September 14, 2000
IPN-00-069

SUBJECT: Indian Point 3 Nuclear Power Plant
Docket No. 50-286
Proposed Improved Technical Specifications
Reply to NRC Request for Additional Information

**NYPA REPLY TO NRC RAI
REGARDING REVISION 0 OF PROPOSED ITS**

Heatup Limitations for the Reactor Coolant System
Figure 3.4.3-1:

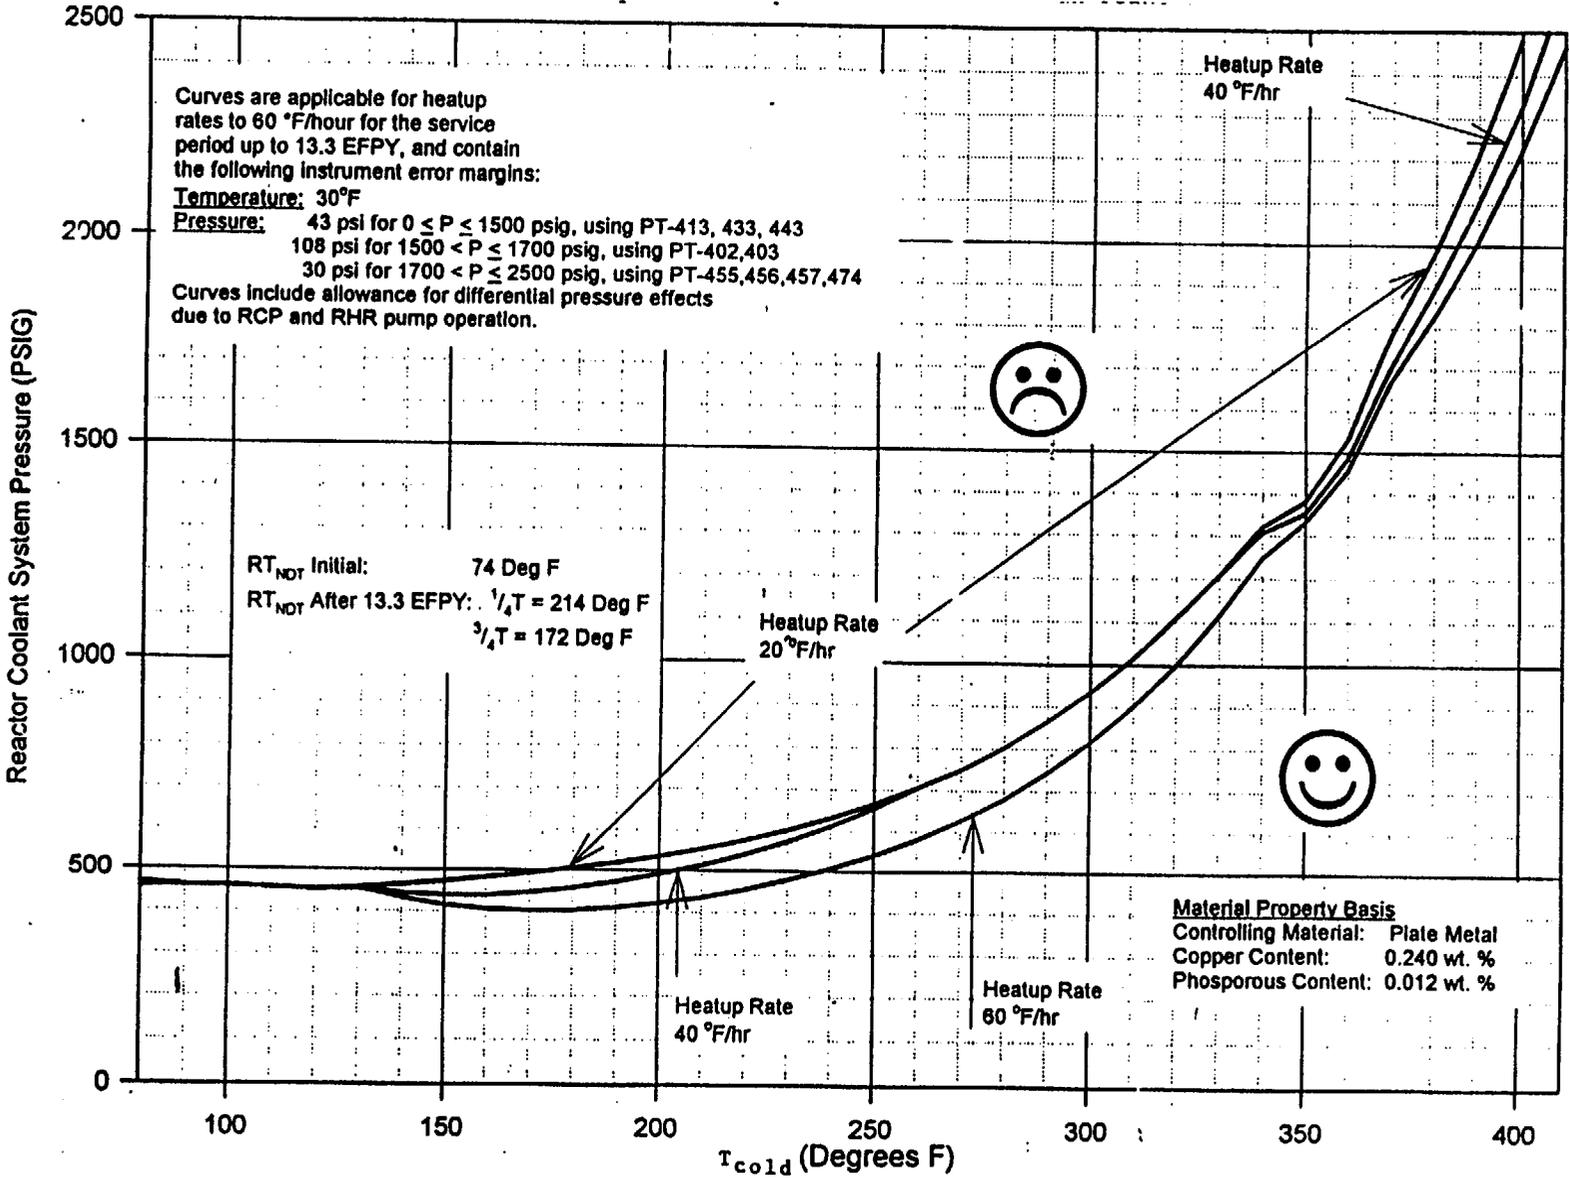
LCO 3.4.3, SR 3.4.3.1, PA.1 - Since IP-3 does not have a PTLR, delete reference to PTLR. Include and list the Figures that apply.

CTS 3.1.B identified that Figure 3.1-1 and 3.1-2 are effective for the service period up to 13.3 effective full-power years (EFPYs). DOC LA.1 item "d" states that Figures 3.1-1 and 3.1-2 are valid up to 11.00 effective full-power years. The CTS and DOC LA.1 conflict on what the service period CTS Figures 3.1-1 and 3.1-2 are effective. Revise the DOC to correctly identify the effective period for CTS Figures 3.1-1 and 3.1-2.

RAI
-5

NYPA has revised the ITS conversion submittal to eliminate relocation of required information to the PTLR. Therefore, the notation that Figure 3.1-1 and 3.1-2 are effective for the service period up to 13.3 will be retained in the ITS as part of Figures 3.4.3-1, 3.4.3-2, and 3.4.3-3. This change will correct the conflict described in this RAI.

LCO 3.4.3 RCS pressure, RCS temperature, and RCS heatup and cooldown rates shall be maintained within the limits specified in Figure 3.4.3-1, Figure 3.4.3-2, and Figure 3.4.3-3.

Figure 3.4.3-2:
Cooldown Limitations for the Reactor Coolant System

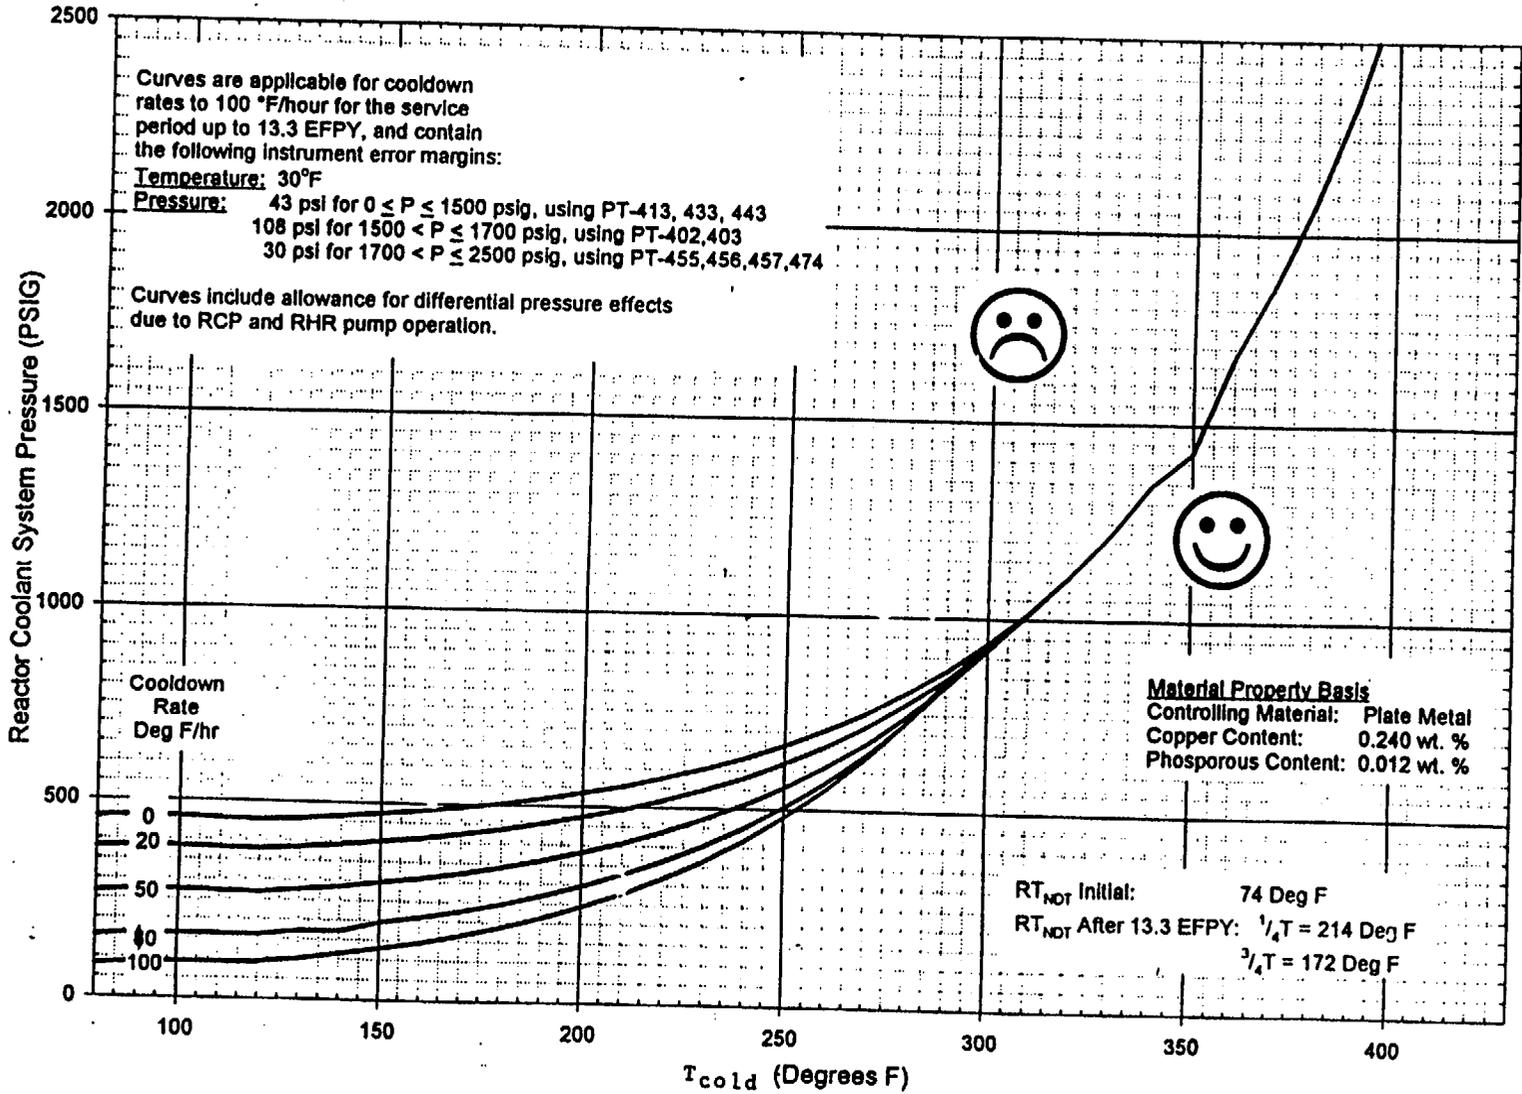
DOC LA.1 does not discuss the second sentence of CTS 3.1.B.1.a that allows interpolation of the limit lines for cooldown rates. This information is required in the DOC to justify information removal from the CTS. Provide documentation to support removal from CTS.

RAT-6

NYPA has revised the ITS 3.4.3, DOC LA.1, to show that the CTS 3.4.3.B.1.a stipulation that allows interpolation of the limit lines for cooldown rates is included in the information that is being relocated to the Bases. (Note: LA.1 was revised to maintain some items in the ITS and relocate others to the Bases consistent with the response to RAI 3.4-05.)

Figure 3.4.3-3: Hydrostatic and Inservice Leak Testing Limitations for the Reactor Coolant System

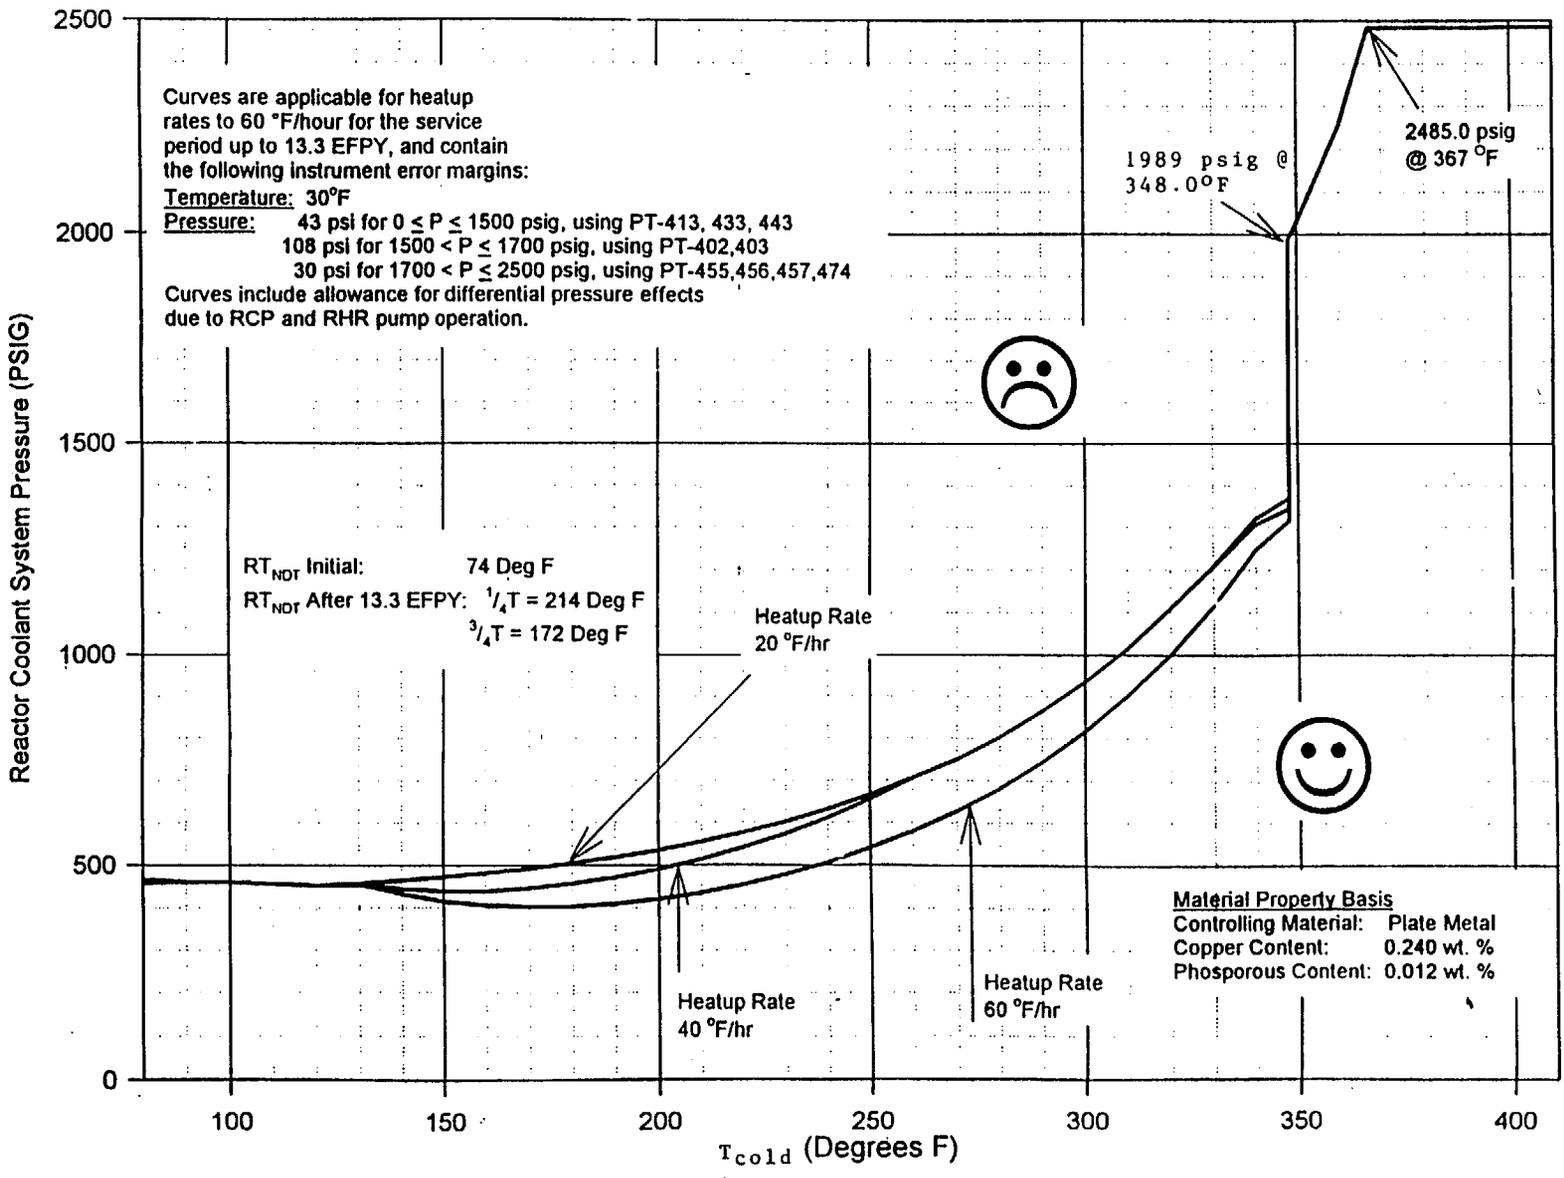
CTS 4.3.A.c states that Figure 4.3-1 is applicable for the first 13.3 EFPYs of operations. This information is not included in the list of details removed per DOC LA.1. Provide documentation for the removal of this information from CTS.

RAI
6

NYPA has revised the ITS conversion submittal to eliminate relocation of required information to the PTLR. Therefore, the notation that CTS 4.3.A.c Figure 4.3-1 are effective for the service period up to 13.3 will be retained in the ITS in Figures 3.4.3-1, 3.4.3-2, and 3.4.3-3. This change will correct the conflict described in this RAI.
